# United States Patent and Trademark Office

APPLICATION NO.	FILING DATE	FIRST NAMED INVENTOR	ATTORNEY DOCKET NO.	CONFIRMATION NO.
10/579,193	05/12/2006	Shigeru Ichikawa	0943-0166PUS1	6727
	7590 12/20/2007 ART KOLASCH & BIRCH	EXAMINER		
PO BOX 747		GORDON, BRYAN P		
FALLS CHUR	CH, VA 22040-0747		ART UNIT	PAPER NUMBER
			2834	
		•	NOTIFICATION DATE	DELIVERY MODE
			12/20/2007	ELECTRONIC

#### **DETAILED ACTION**

Figure 2

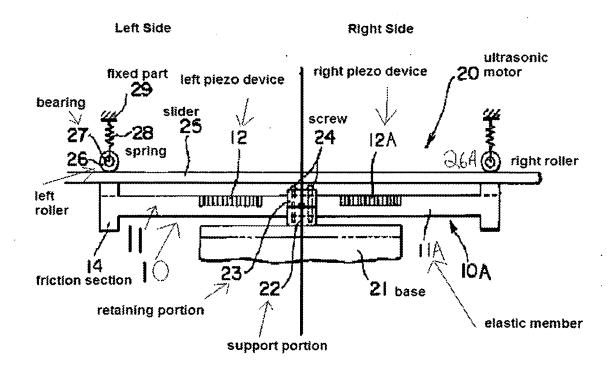
3. Considering claim 1, Tomoki (Figure 2) teaches a drive device (paragraph 0012) of an ultrasonic linear motor (10) in which a rail (25) and a base body (21) are driven

movably relative to one another by a driving part interposed between the rail and the base body, at least a pair of right (26A) and left rollers (26) making contact with side faces of the rail, at least a pair of right (10A) and left ultrasonic (10) vibrators for applying a turning force individually to each of the pair of right and left rollers, an urging member (14) that urges the ultrasonic vibrator and the rollers toward the side faces of the rail; wherein each of the pair of right and left ultrasonic vibrators is comprised of a piezoelectric device (12, 12A) and vibrating elastic member (11, 11A) integrally affixed to the piezoelectric device, and each of the pair of right and left rollers is adapted to be turned by vibration of the respective elastic member.

- 4. Considering claim 2, Tomoki (Figure 2) teaches the claimed invention as described above and the holding frame (23).
- 5. Considering claim 4, Tomoki (Figure 2) teaches the claimed invention as described above.
- 6. Considering claim 5, Tomoki teaches the claimed invention as described above in claim 1.
- 7. Considering claim 6, Tomoki teaches the claimed invention as described above in claim 2.
- 8. Considering claim 8, Tomoki teaches the claimed invention as described above in claim 2.
- 9. Considering claim 9, Tomoki (Figure 2) teaches wherein the base body is movably supported on an upper surface of the rail (25) by bearings (26) disposed on a bottom face of the base body (21).

The examiner has also provided a picture of the drawing outlying what the examiner used to reject the piezoelectric element and elastic body. As can be see by the Figure 2 the elastic member is affixed to the piezoelectric elements.
